TECHNICAL BULLETIN
LTB00477v2
20 AUG 2012

SECTION: 308-01

Clutch Noise

Defender (LD)

1. Damaged or missing thrust washer.
2. Correctly located thrust washer.

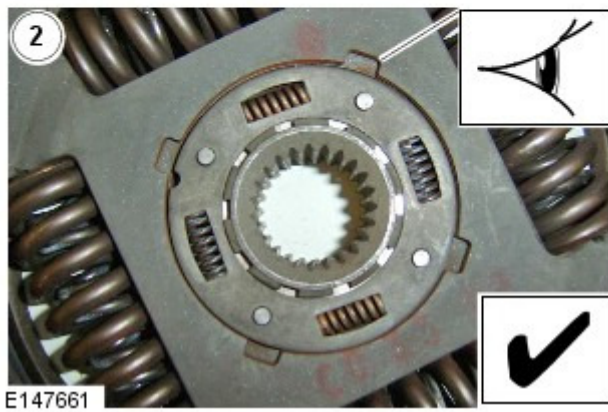
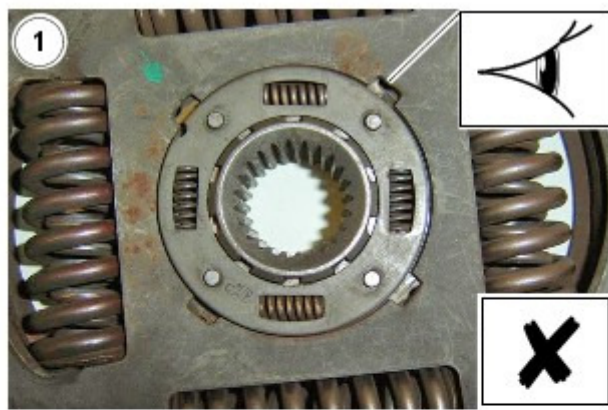
Cause: The thrust washer fitted around the centre hub of the clutch disc may have sheared (this does not cause operation failure of the clutch it generates an audible noise only). **Suggested Customer Concern Code - P24.**

1. Remove the clutch disc and pressure plate (see TOPIx Workshop Manual, section 308-01).
2. Inspect the clutch disc for signs of damage to the thrust washer.

NOTE: The new design clutch disc has a gloss finish and a bonded thrust washer.

Install the new design clutch disc and pressure plate (see TOPIx Workshop Manual, section 308-01).
